Docket No. 217 - Development and Management Plan Inspection

Northeast Utilities Service Company Certificate of Environmental Compatibility and Public Need for the construction of a 345-kV electric transmission line and reconstruction of an existing 115-kV electric transmission line between Connecticut Light and Power Company's Plumtree Substation in Bethel, through the towns of Redding, Weston, and Wilton, and to the Norwalk Substation in Norwalk, Connecticut.

Date: October 4, 2006

Location: 345kV XLPE Component

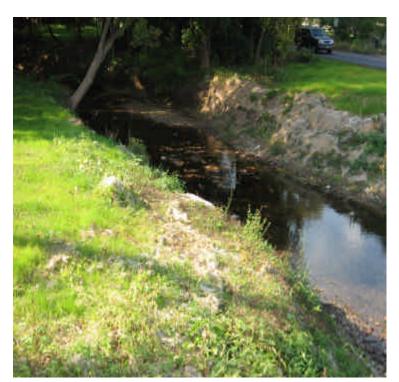
Photo on the left shows good restoration efforts (seed and mulch) in vault access areas. Photo on the right shows the jacking pit side at the jack & bore following restoration. Grass cover is establishing well and the erosion control matting remains in good shape. 10/04/06
